P	age No.		Page No.
SELF TESTING RAMS & ROMS	1	RALLY-X CODE	43-44
ROMS & PROM CHART	2	GORF CARD RACK SYSTEM	45
GAME NUMBERS	3—6	GORF MISSION SELF TEST	46
DIFFERENT POWER SUPPLIES	7	GORF PROGRAM CHANGE	47—49
ANTI CHEAT DEVICES	8—10	SPECIAL ALLEN WRENCH	50
ANTI-WIRE COIN SWITCH	11	FREE GAMES HITTING COIN DOOR	51
NEW MEDIUM POWER SUPPLY	12	ANTI-STATIC CLEANER	<b>52</b>
LAZARIAN LOCK-UP CONDITION	13	NEW BACK DOOR KEY .	53
TRON LINE FUSE CHANGE	14	CREDIT BYPASS JACK	54
TRON CONTROL ASSEMBLY	15	COLOR MONITOR BRIGHTNESS ADJUSTMENT	55
TRON - KICKMAN HUM IN SOUND	16	PAC-MAN DIP SWITCHES	56
MS. PAC-MAN & GALAGA WAVY VIDEO	17	PAC-MAN ROM & RAM TEST CODE	57
MS. PAC-MAN & PAC-MAN LOSS OF SOUND	18	CARD RACK SYSTEM TEST CARDS	58
COIN METER WITH CLAMPING DIODE	19	SPACE ENCOUNTER STROBE UNIT FIX	5 <del>96</del> 0
MS. PAC-MAN MAIN LOGIC BOARD	20	SPACE ENCOUNTER GAME BOARDS	61
KICK & KICKMAN NEW FEATURES	21	SPACE ENCOUNTER 25K POTS	6263

#### **SERVICE BULLETIN**

#### **ANTI-CHEAT COIN CHUTE REWORK**

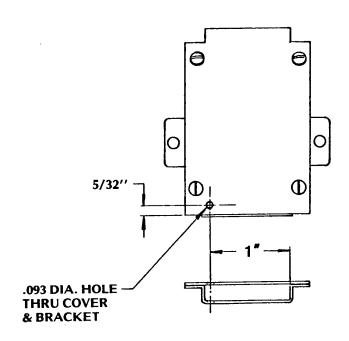
- 1. DRILL .093 DIA. HOLE THRU COVER AND BRACKET AS SHOWN.
- 2. REMOVE BURRS FROM EDGES OF HOLE AFTER DRILLING.
- 3. INSERT 1/16" DIA. COTTER PIN.
- 4. PIN MUST MOVE FREELY.
- 5. OBJECT IS TO KICK PENNY TO THE RIGHT AND SLOW IT DOWN.
- 6. MAKE SURE QUARTER WILL PASS THROUGH AFTER COTTER PIN IS INSERTED.

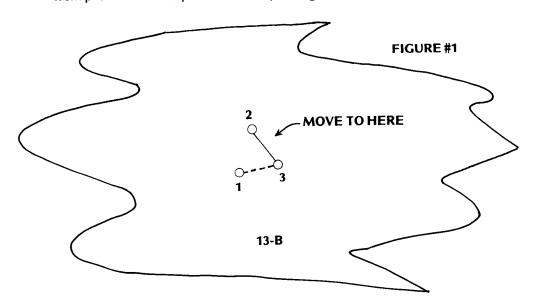
SUBJECT: LOCK UP CONDITION ON POWER OFF & ON

1. Enable the watchdog circuit by moving the jumper wire near location 13-B from position 1 & 3 to position 2 & 3. (See Figure #1).

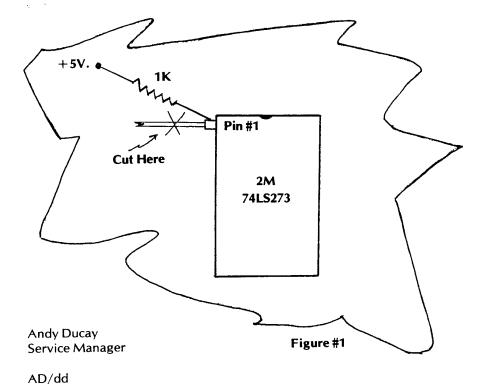
SUBJECT: INTERMITTENT LOSS OF SOUND (STATIC)

1. Cut trace to pin #1 of 2M (74LS273).

2. Solder 1K resistor from +5VDC to pin #1 of IC 2M. (See Figure #1).

Strobe unit PC A084-91359-B645 Serial No. 101 to 3700

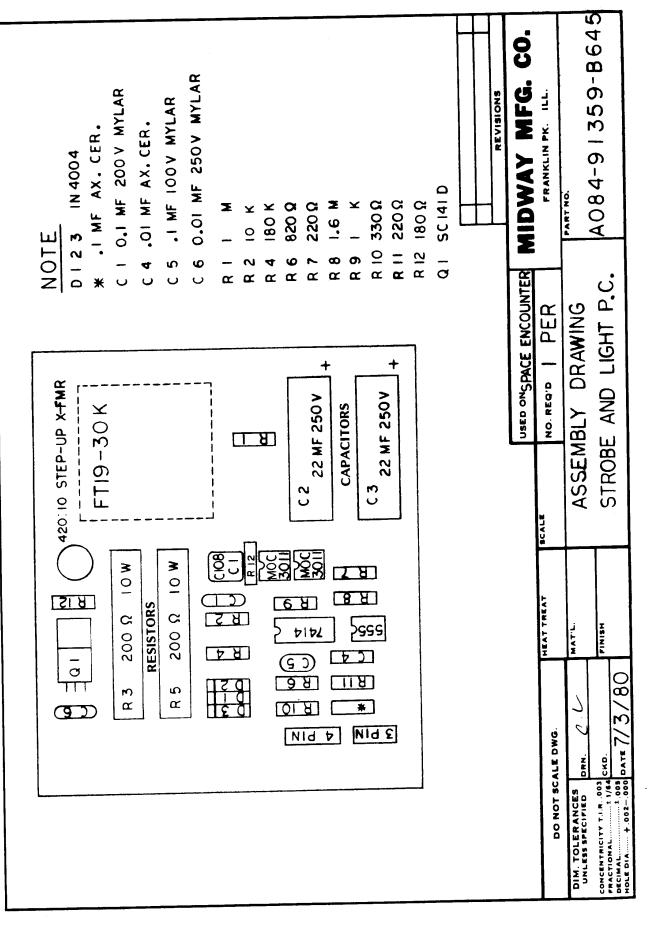
MODIFICATION: (see figure #1)

1. Change resistor R3 and R5 to one of the following values.

- 1. 300 ohms, 20 watts. 10%.
- 2. 310 ohms, 20 watts. 10%.
- 2. Capacitor C-2 and C-3 should be 22MF., 250 V.
- 3. Check electrically.

# ANTI-STATIC INSTALLATION INSTRUCTIONS FOR GALAXIAN FIGURE #1

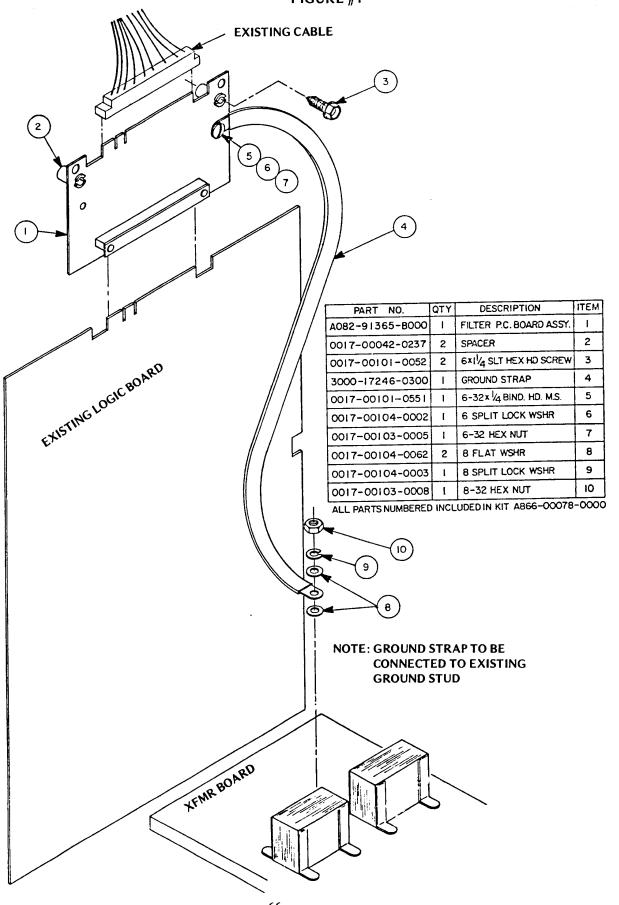
Static Condition Causing A False

Ram and Rom Test.

- Order from the Midway Parts Department an Anti-Static Kit PC A866-00078-0000 and install as shown in instruction diagram. (Fig. #1)
- 2. Check game out electrically.

**REVERSE PIN #18 & 20 AS SHOWN**

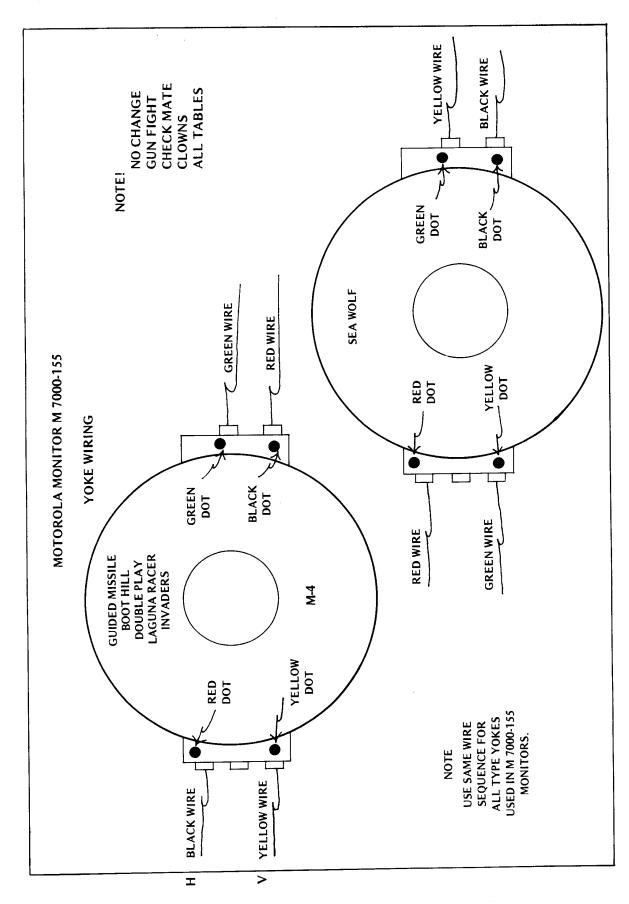
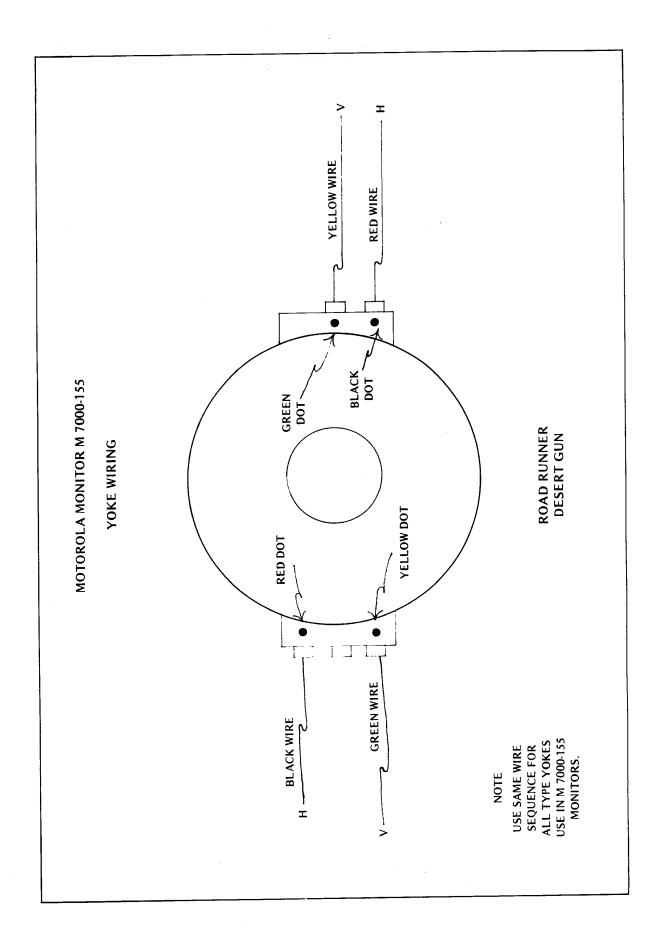
- 1. Refer to figure #1 for proper strapping of jumpers and capacitor removing or relocating.
- 2. Cut pins #18 and #20 of each prom and jumper as shown in figure #2.
- 3. Check electrically.
